**RE: Proposed Multi-Family Development  
Louise Berry Drive**

In response to your review comments on the referenced project dated March 9, 2021, we offer the following:

# PROPOSED MULTI-FAMILY CONDOMINIUM DEVELOPMENT

LOUISE BERRY DRIVE  
BROOKLYN, CONNECTICUT

EROSION CONTROL AND UTILITIES PLAN

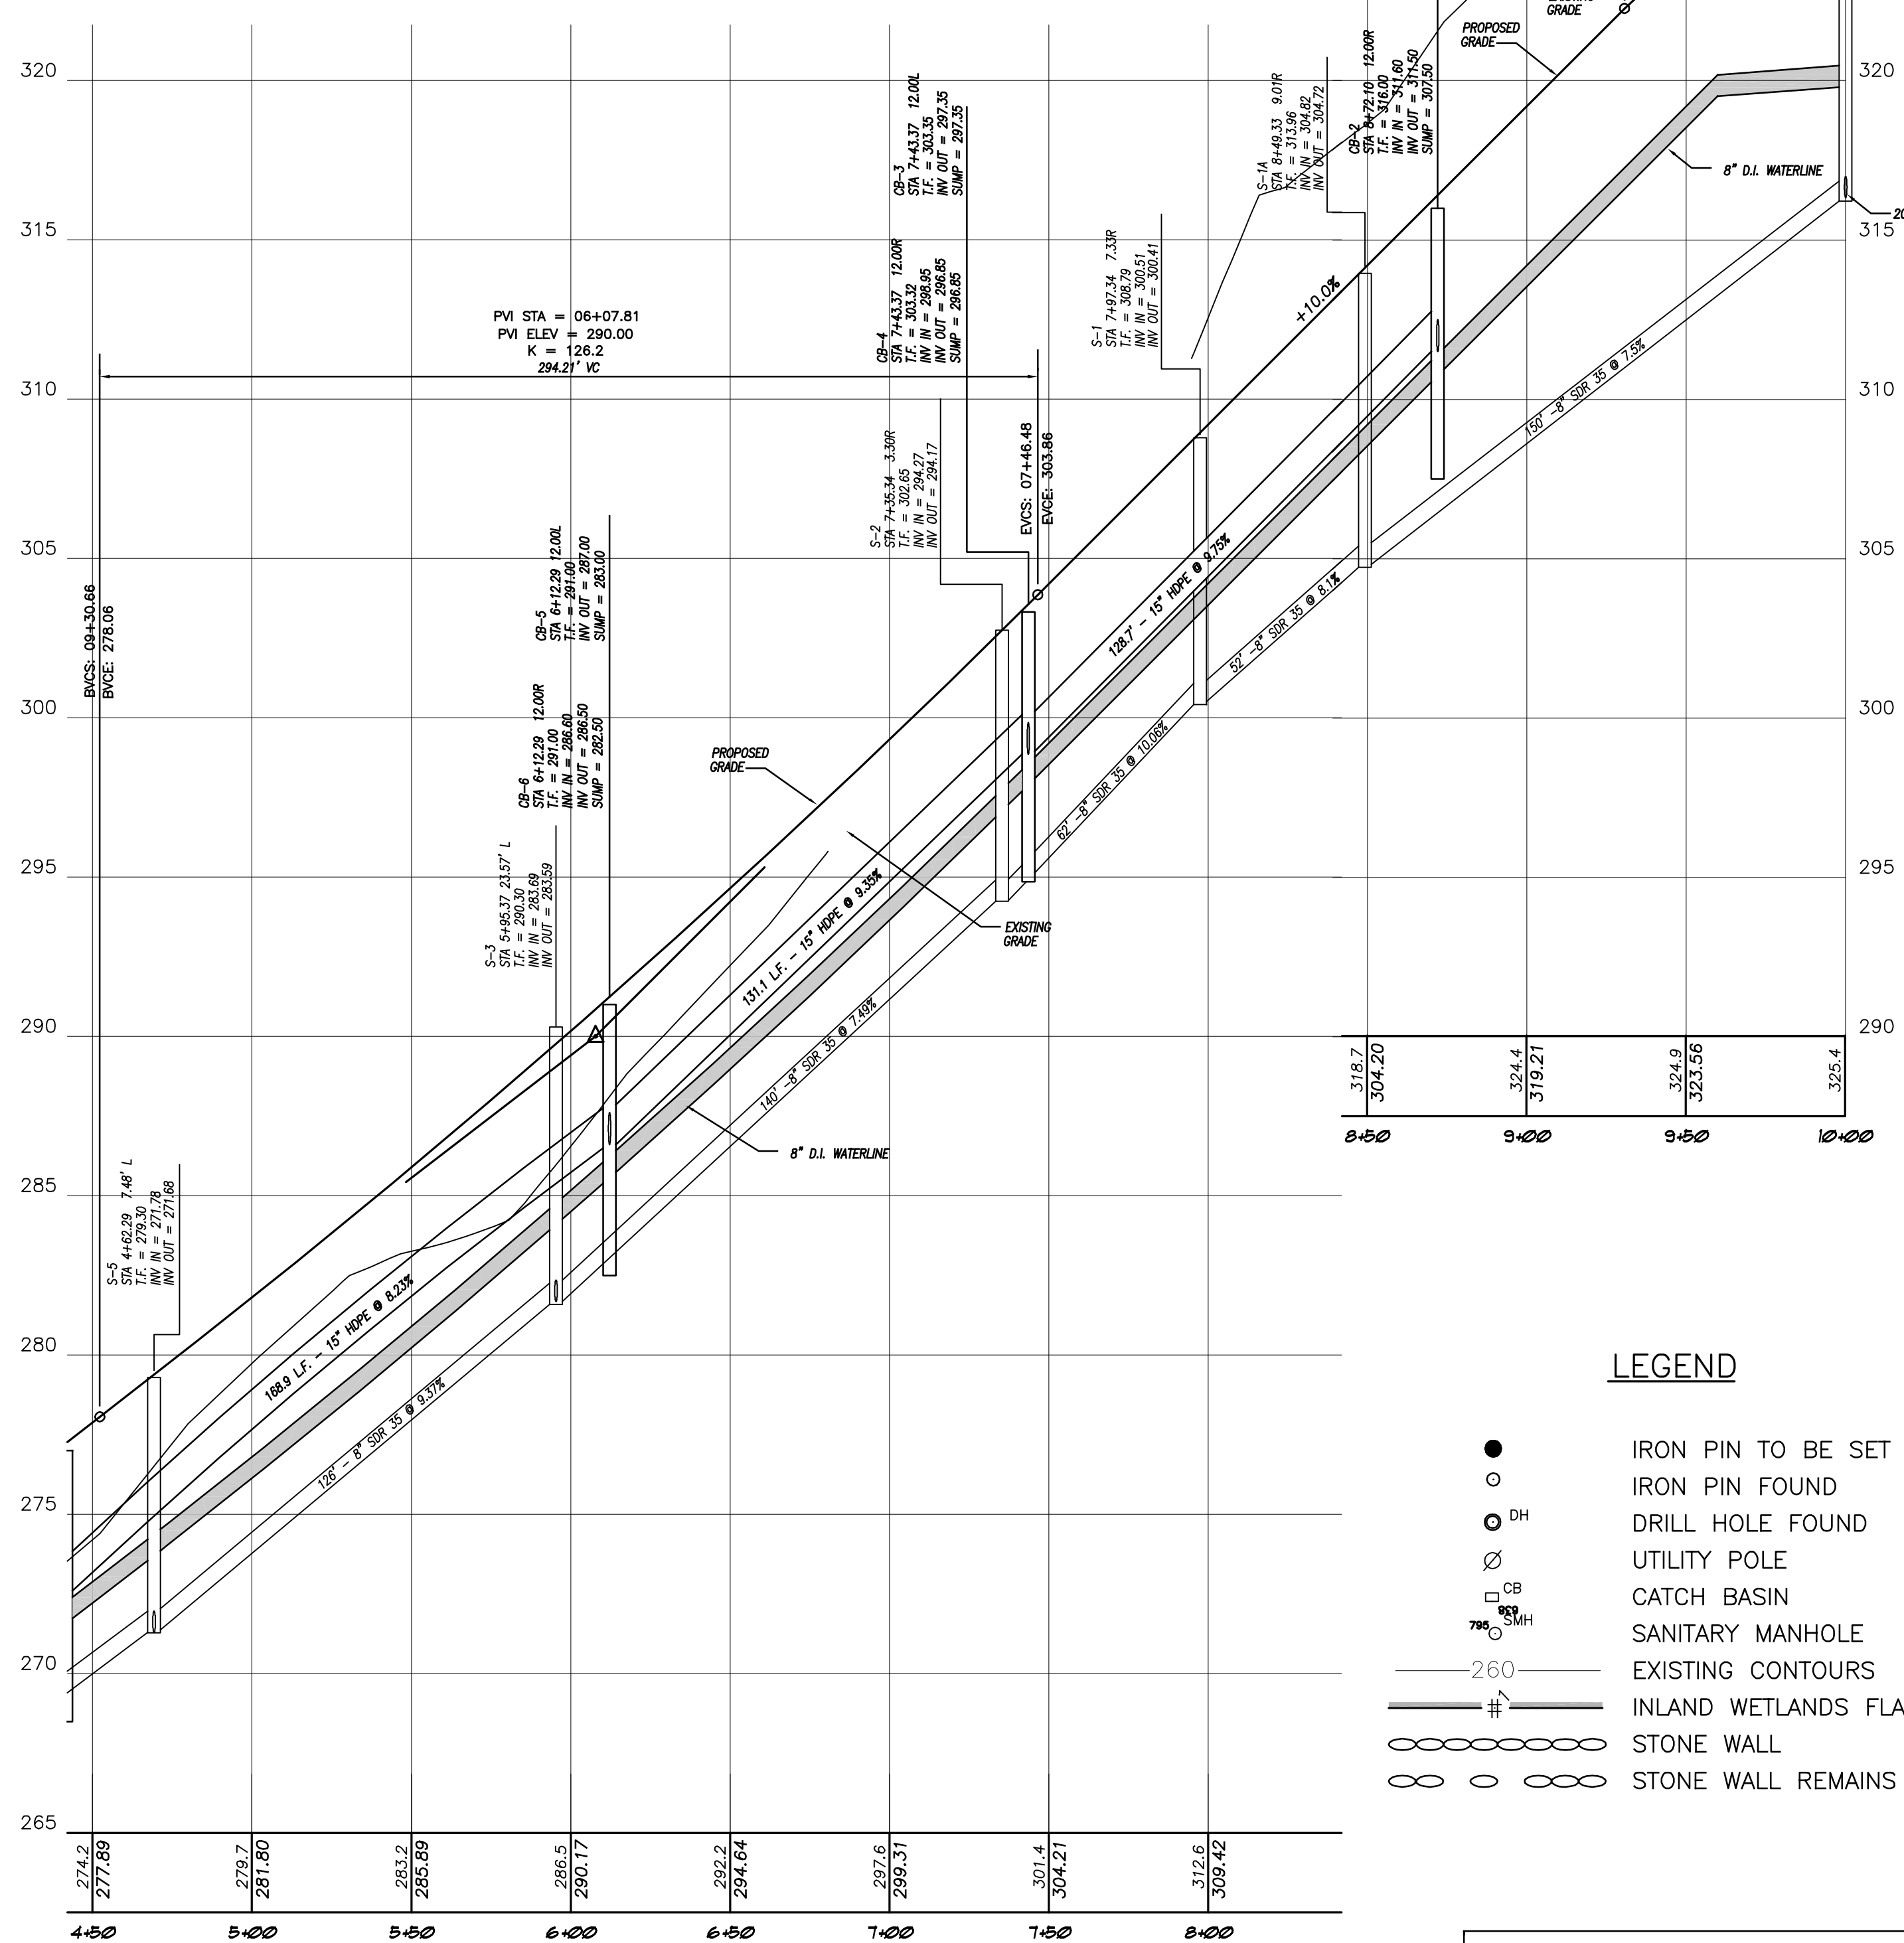
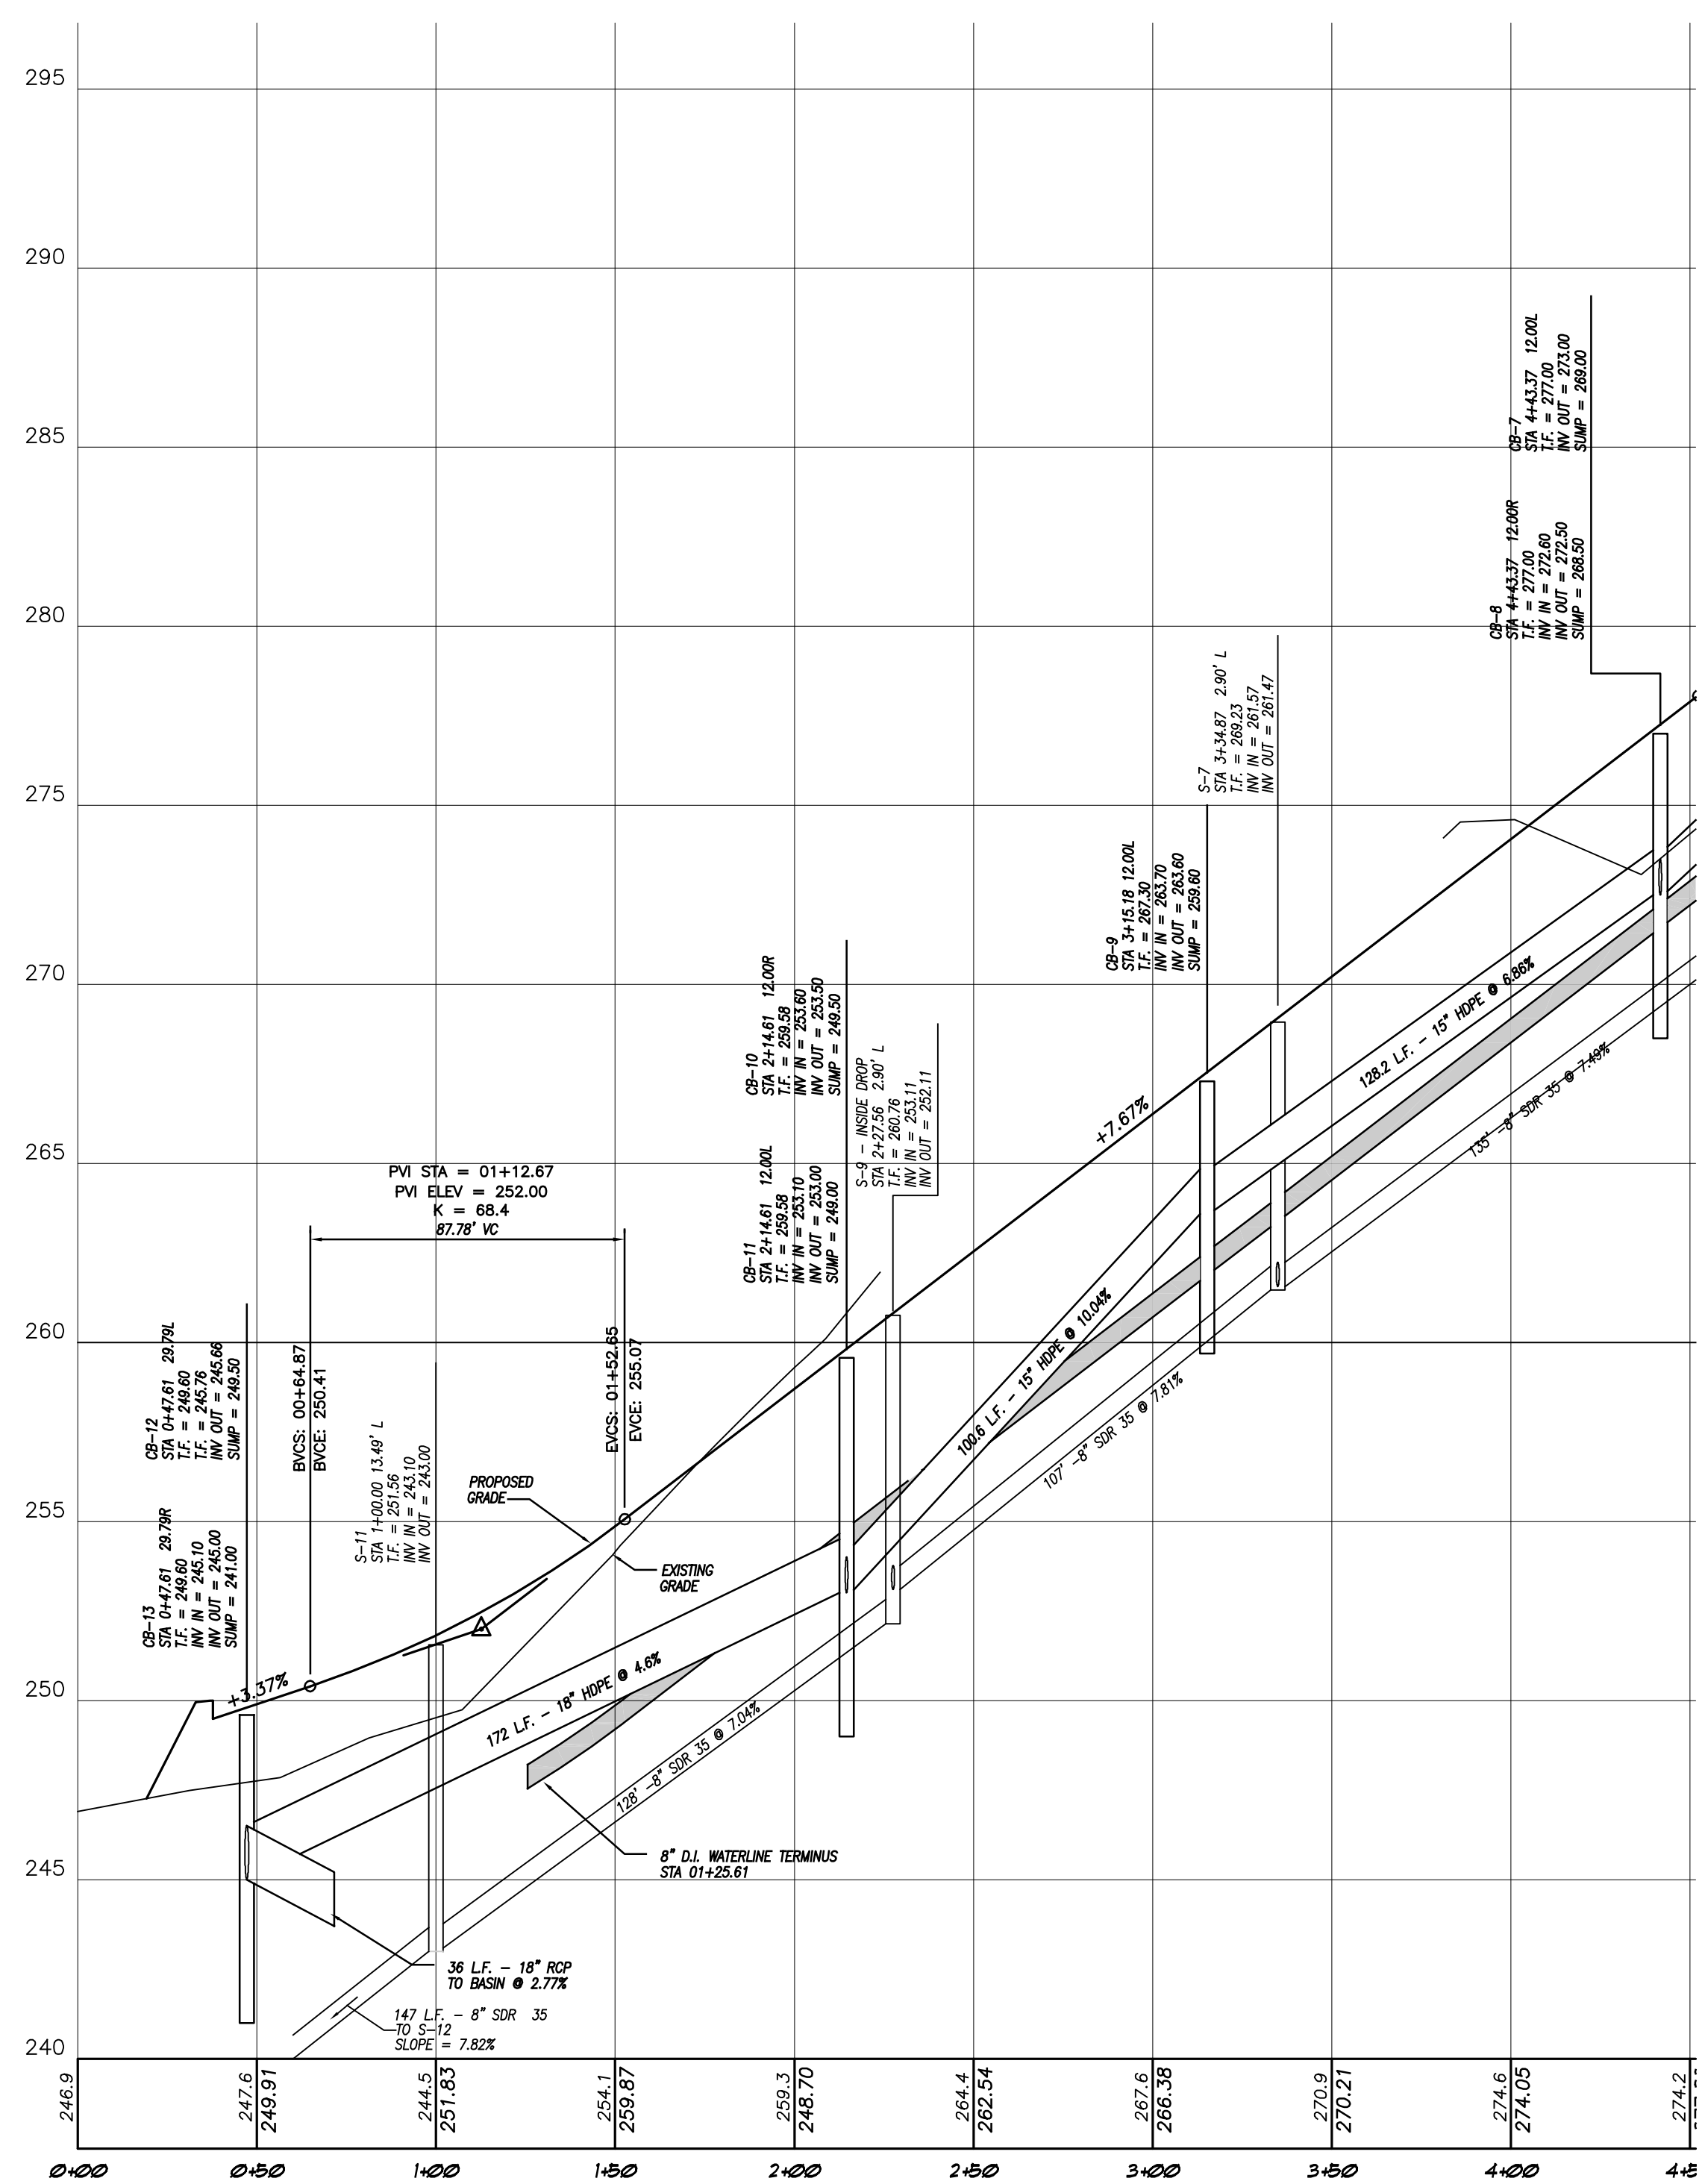
- Additional jute netted has been added to the E&S controls on sheet 6 between the wetlands and units 1-3 and 4-8 as requested.
- A note regarding only clearing of vegetation and no grubbing prior to the installation of erosion controls and approval by the Agent has been added to sheet 8 of the plans (see development schedule/sequence of operations).

- Notation has been added to sheet 6 of the plans stating that the swale and temporary sediment rap shall be stabilized prior to discharge into them.
- Notation regarding the mowing of the basins has been added to the operations and maintenance plan, Detail Sheet 4.

WIRE BACKED SILT FENCE

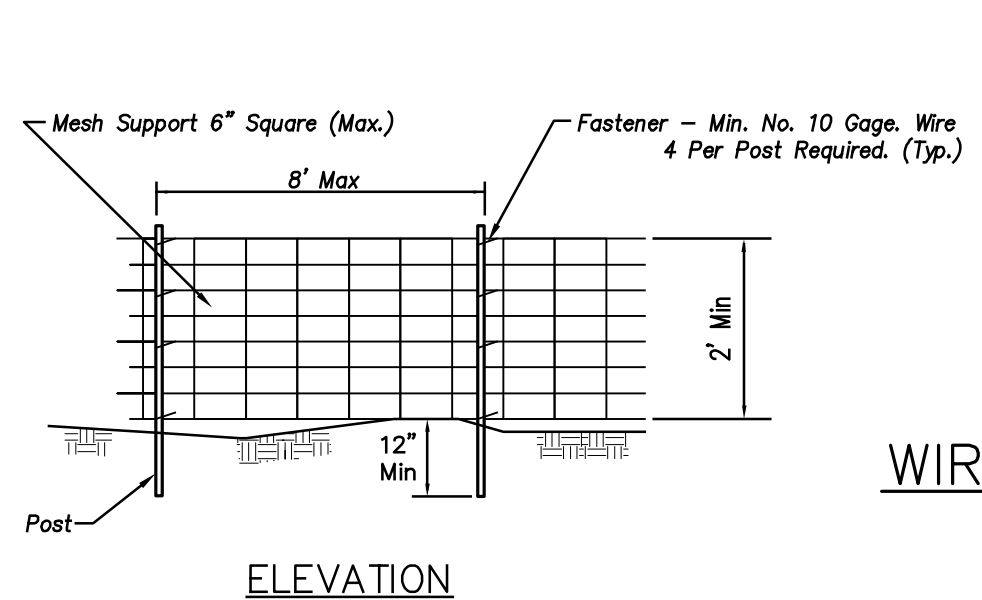
- Perimeter sediment controls in the upland review area have been modified to depict staked haybales backed with wire backed silt fence as requested (sheet 6). A detail for wire backed silt fence has been added to sheet 8 of the plans.

COMPOST FILTER SOCK APPLICATION

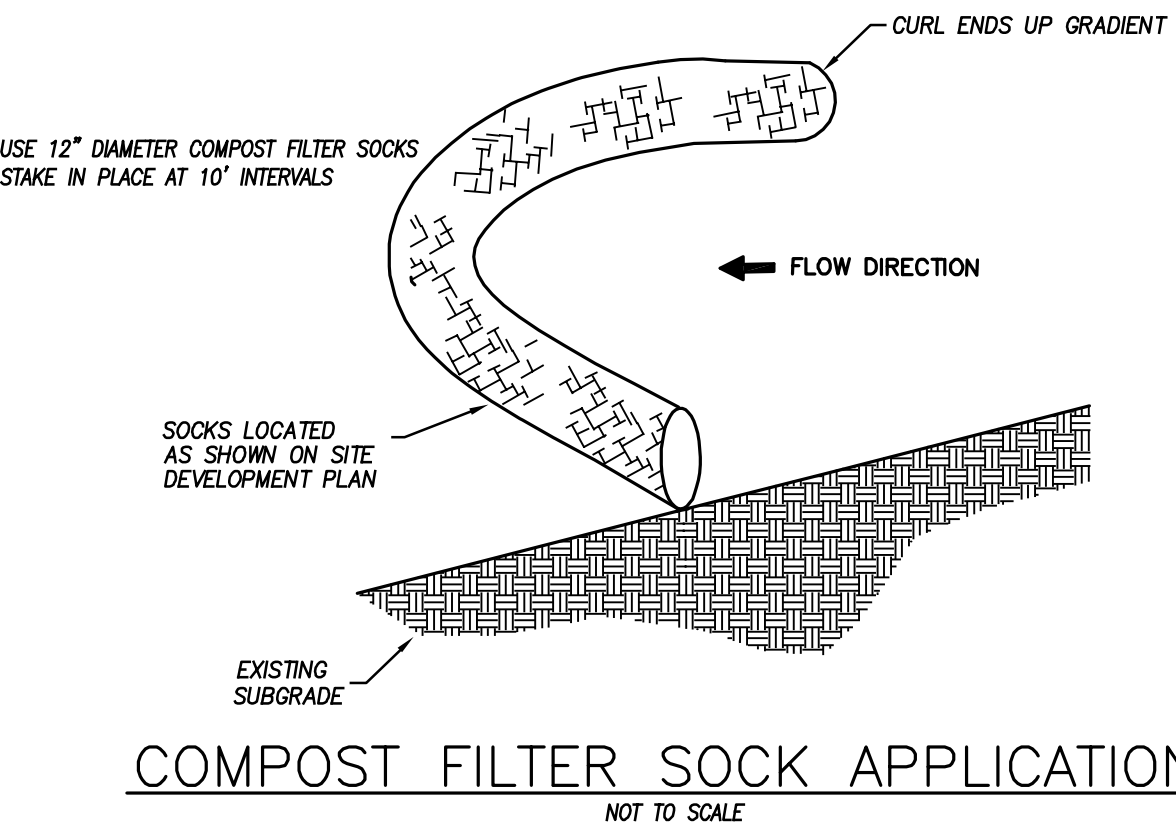
- All straw wattles have been removed from the plans and replaced with compost filter socks as requested. The detail on sheet 8 of the plans has been updated as well.

CONCRETE SIDEWALK DETAIL  
NOT TO SCALE

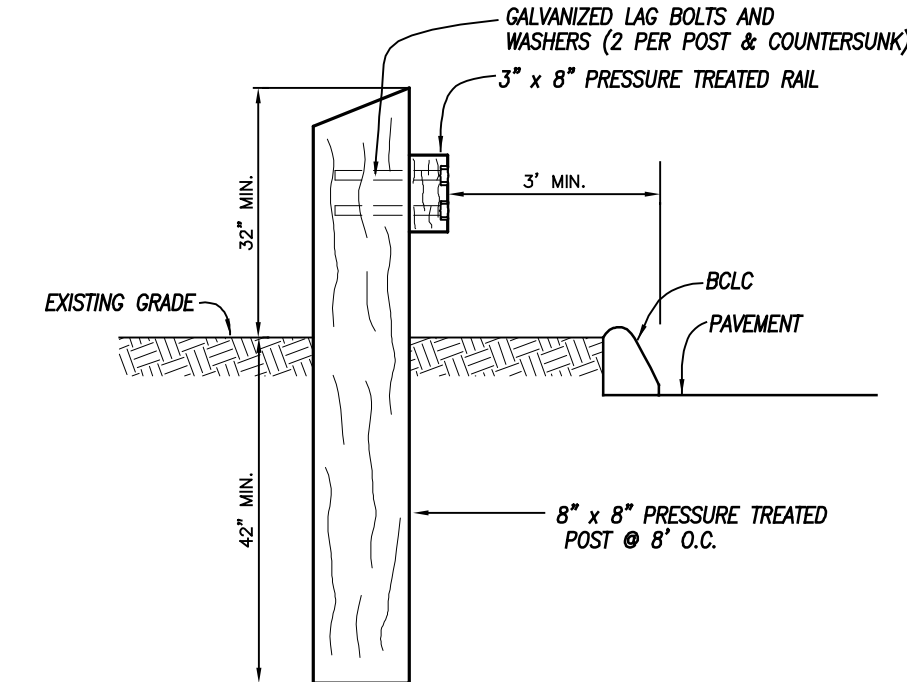
Comment #12 ó The concrete sidewalk depth has been modified to 5" to the BPIS.
